**Tillbridge Solar Project
EN010142**

**Volume 6.2
Environmental Statement
Appendix 10-5: Water Environment Stakeholder
Correspondence
Document Reference: EN010142/APP/6.2**

Environment Agency Preliminary FRA Response

**Tillbridge Solar Scheme, south of the A631 between Heaptham and Hartswell –
Flood Risk Assessment review**

FRA ANNEX B - Fluvial Flood Level Technical Note

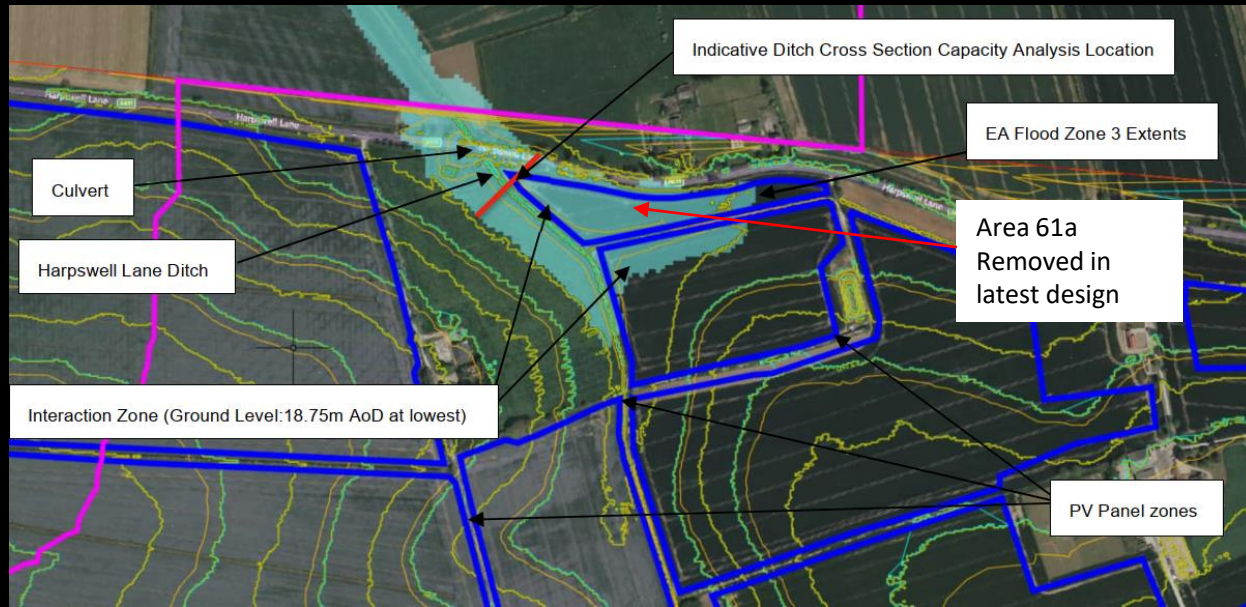
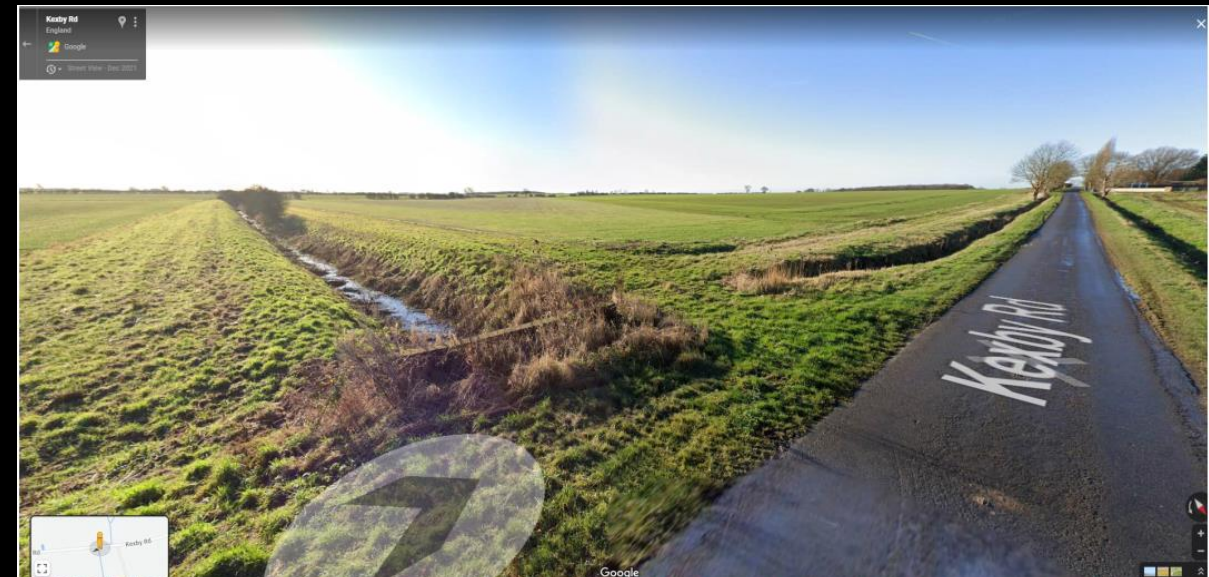
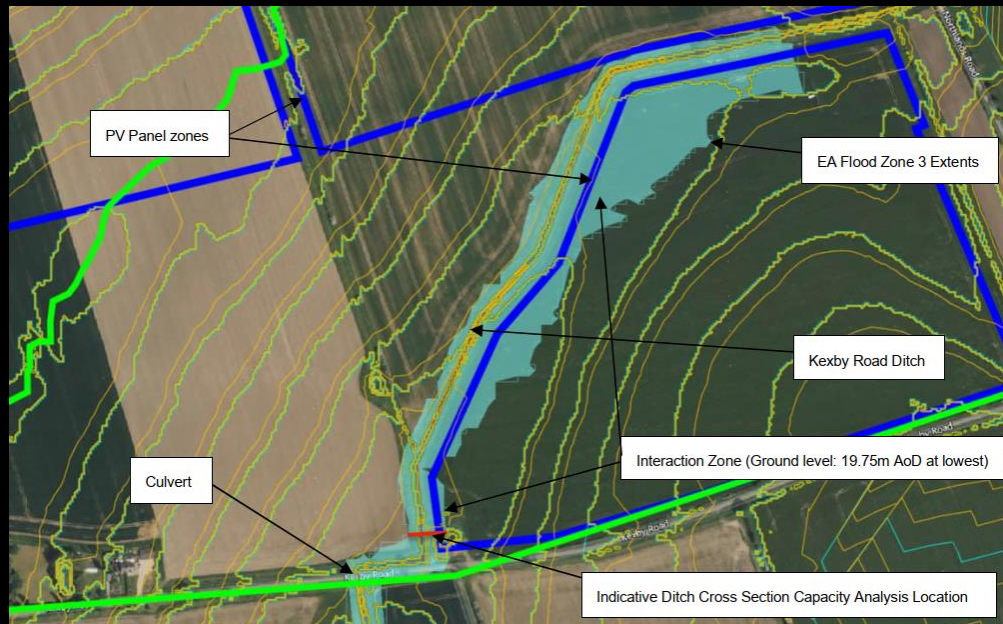
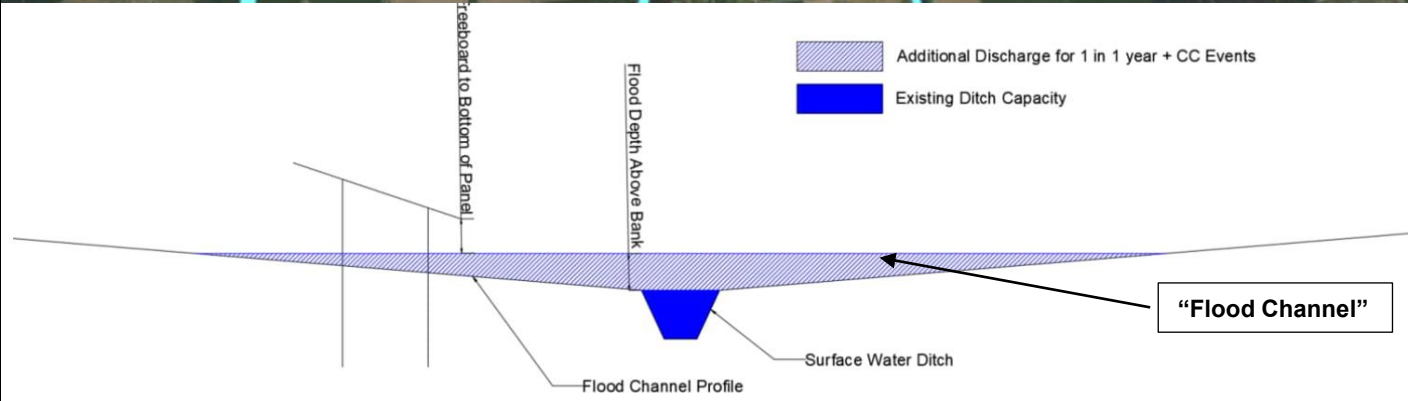
Agreement to Flood Risk Tech Note assessment approach – agree fluvial modelling not required for FRA

- PJ asked if are there any BESS/substations at flood risk or are floor levels/electronics/junction boxes etc. above predicted flood levels.?
- CB indicated panels only in flood zones 2 and 3, no BESS.
- CB discussed that the EA has provided a response to the Preliminary Flood Risk Assessment, in their letter dated 24 May 2023, under agreement ENVPAC/1/LNA/00178, which notes the EA considers the details in the FRA “are appropriate for the scale, nature and location of the proposed

<p>development”, CB discussed the flood risk technical note and asked stakeholders if the climate change assessment in the fluvial flood risk technical note’s (Annex B of FRA) approach presented for the Harpswell Lane and Kexby Road flood risk areas was deemed acceptable with no further hydraulic modelling being proposed to assess flood risk to the panels in Flood Zone 3.</p> <ul style="list-style-type: none"> – No further comments received from group. Matter agreed and closed. 	
7	<p>AOB</p> <p>Foul Water Drainage</p> <ul style="list-style-type: none"> – AH asked if locations of the compounds were known at this time or if they would be provided at detailed design stage. The Environment Agency preference/policy is for foul drainage to be connected to the main sewers, if possible, rather than installation of cesspits. If compounds are near villages, then connection could be possible. – CB indicated that AECOM looks at sewer public records when deciding use of cesspits or connection to mains. On previous projects, if within 20m then we would look to connect to mains. – AH indicated that the Environment Agency expects a connection if within 30m of mains. – CB noted, 30m will be considered. <p>Disapplication of Land Drainage Act</p> <ul style="list-style-type: none"> – GH asked if disapplication of the Land Drainage Act as part of DCO was planned. If so, GH asked how the team intends to slot in agreements with the IDBs. Upper Witham IDB would be happy picking this up using a Statement of Common Ground (SoCG) or Protective Provisions (PPs). – DH indicated this would be looked at going forward and with the legal team. – GH indicated this would be acceptable. – DH asked if a joint SoCG be acceptable or one for each IDB. – PJ and GH indicated this would be on an individual basis; a SoCG is the most useful whether byelaws are disappplied or consent is applied for. <p>Lifetime of Panels</p> <ul style="list-style-type: none"> – PJ asked about the life expectancy of solar panels. – ST explained that the operational period of scheme being assessed in the Environmental Statement is 60 years. <p>Land Ownership/Classification</p>	ST

Potential Horizontal Directional Drilling Crossings

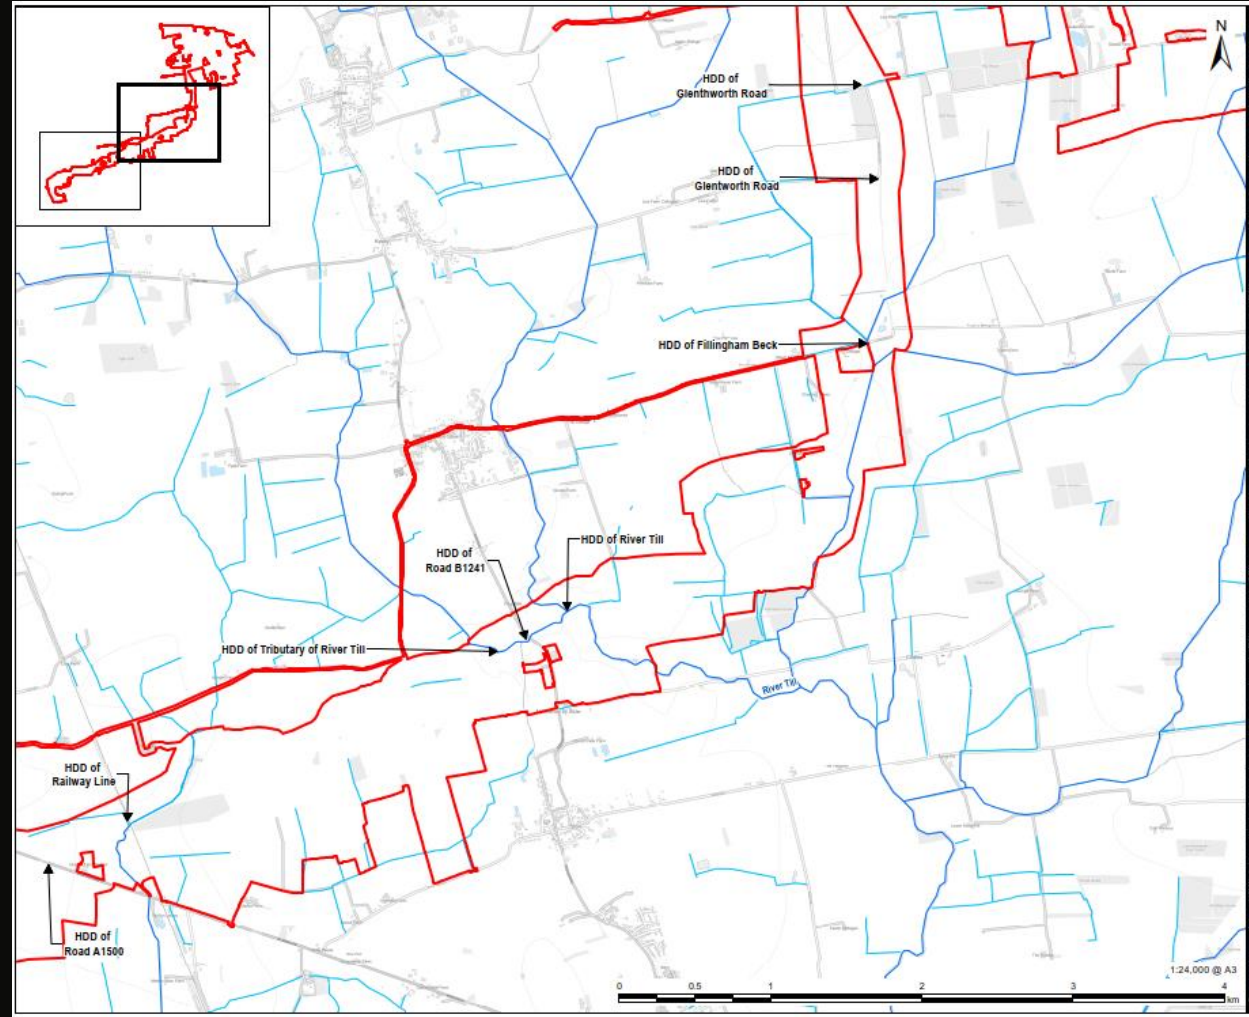
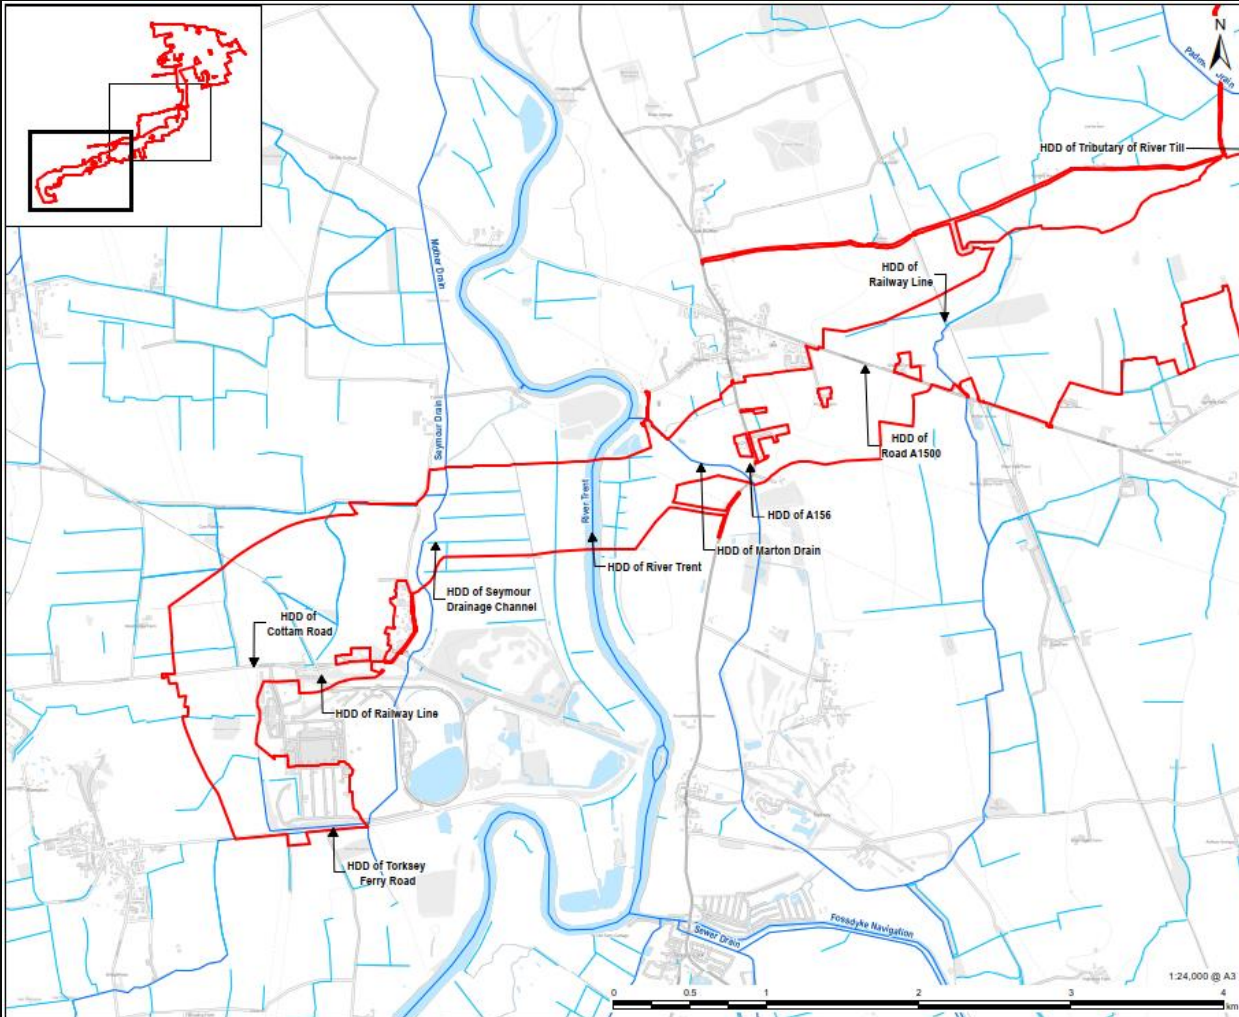
6	<p>Points for agreement:</p> <p>All channels in Trent Valley IDB to be non-intrusively crossed.</p> <ul style="list-style-type: none"> – DC confirmed that the expectation for all watercourses in Trent Valley IDB area to be non-intrusively crossed. HDD or similar. <p>Agreement of point of measurement for the buffer zones on watercourses:</p>	DH, IH & CB

Agreement of the crossings of WFD monitored reaches by HDD:

- The Environment Agency agreed.
- PJ indicated Scunthorpe and Gainsborough IDB channels will have to be HDD or similarly crossed as well. PJ will send shapefile to identify these courses.
- GH stated that Upper Witham IDB will also send shapefile of watercourses. Upper Witham IDB will need finalised Cable Route Corridor to confirm all. GH noted that the temporary works crossings are of most concern and requested a shapefile of Scheme.
- CW indicated from the perspective of the Environment Agency, the River Till crossing will need to be trenchless as well. Exemption will need to be registered with expectations of HDD, so that local teams are aware of works.
